Urmi Garments Ltd. (New Factory)

17 May 2022

Observations

3RD FLOOR LOAD PLAN

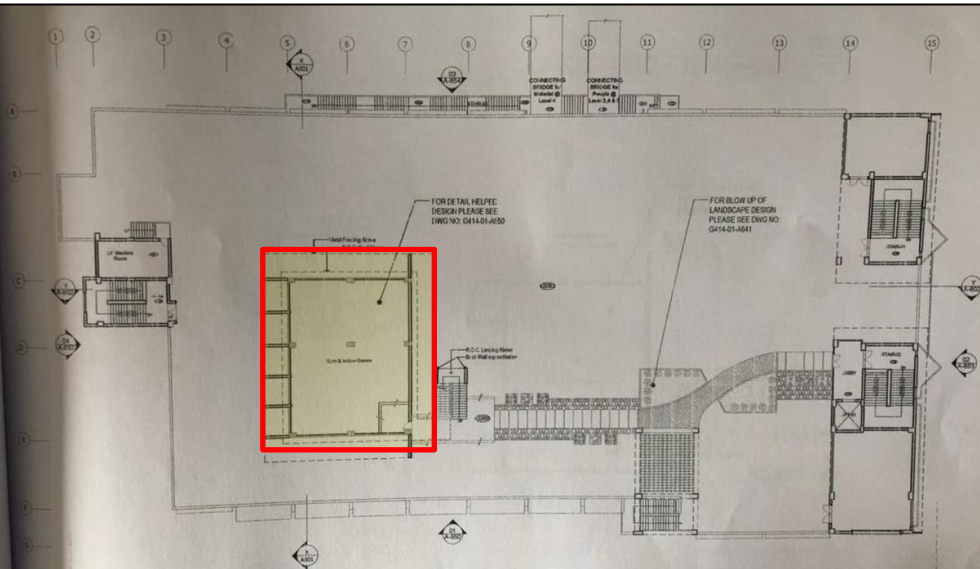
3rd floor Layout Plan. Fabric store at marked area.

At 3rd floor, fabric store has been shown in layout in marked location. The live load of that area has been considered 5 kPa. As per BNBC, minimum loading 6 kPa is required for the light storage. Factory engineer is required to update the floor loading plan, software-based analysis and design report following BNBC loading requirement.

Gym & indoor game room at marked location

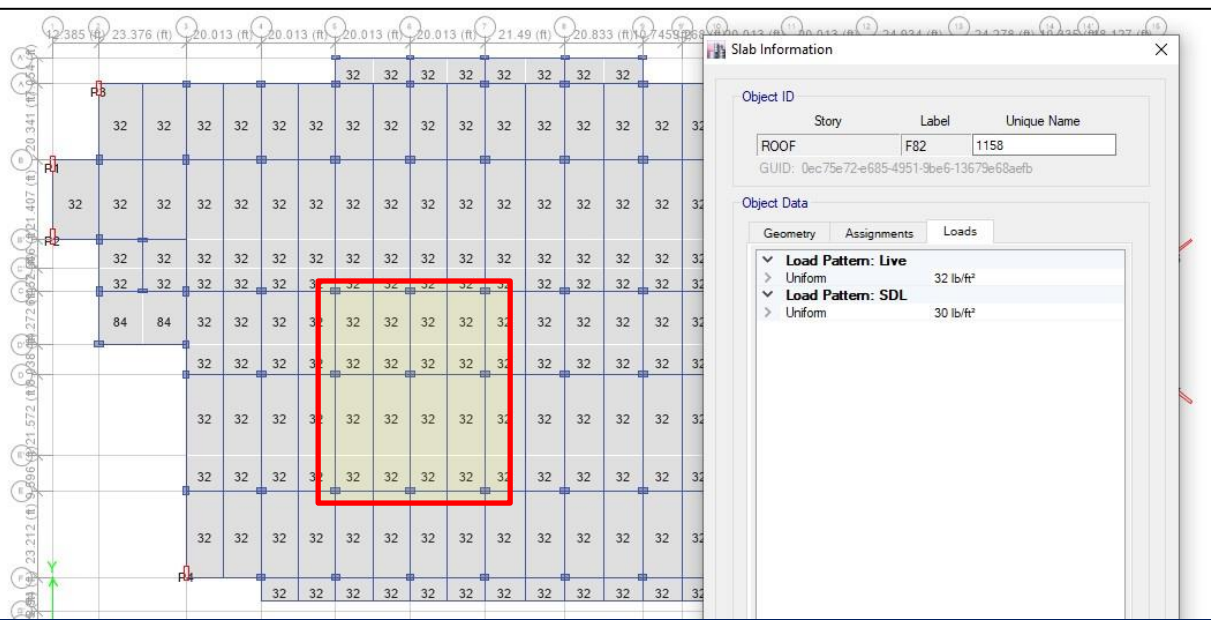
Gymnasium & indoor game room has been proposed at roof level below helipad frame. The live load of that area has been considered 32 psf (1.5 kPa) in FEA model and load plan was not available for the roof level. As per BNBC, minimum loading 3 KPa is required for the fixed seat gymnasium. Factory engineer is required to update the floor loading plan, software-based analysis and design report following BNBC loading requirement.

Live load considered 32 psf (1.5 kPa) in FEA model

1st floor Layout plan

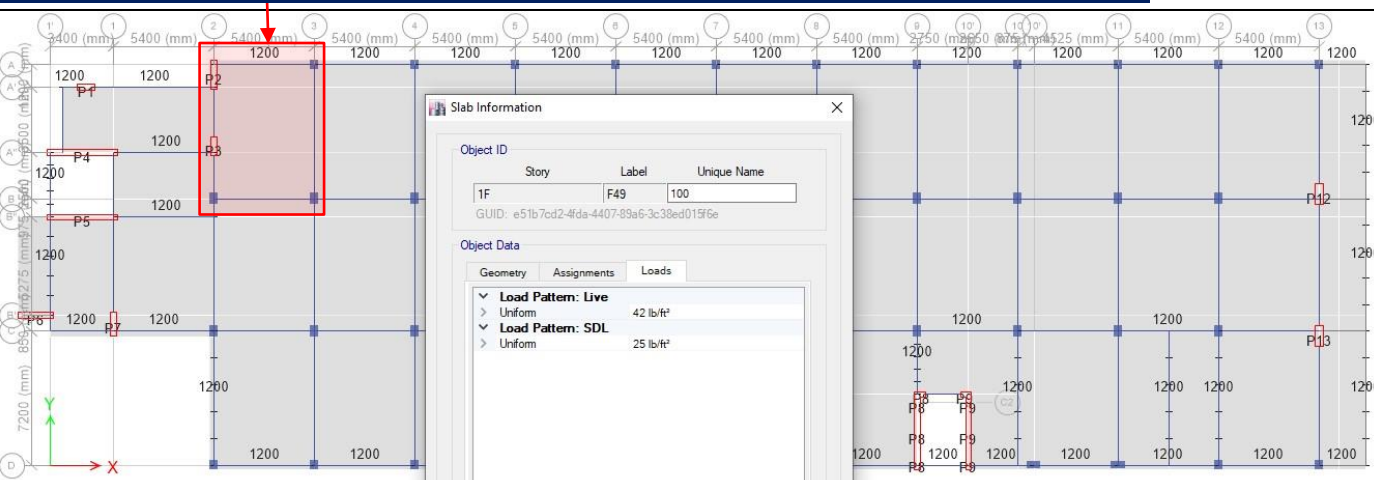
Toilet partition wall loading not considered – marked location

At 1st floor, 2.44 m toilet partition wall was found. But the loading from the 125 mm brick wall has not been in ETABS FEA model. Factory engineer is required to update the floor loading plan, software-based analysis and design report following BNBC loading requirement.
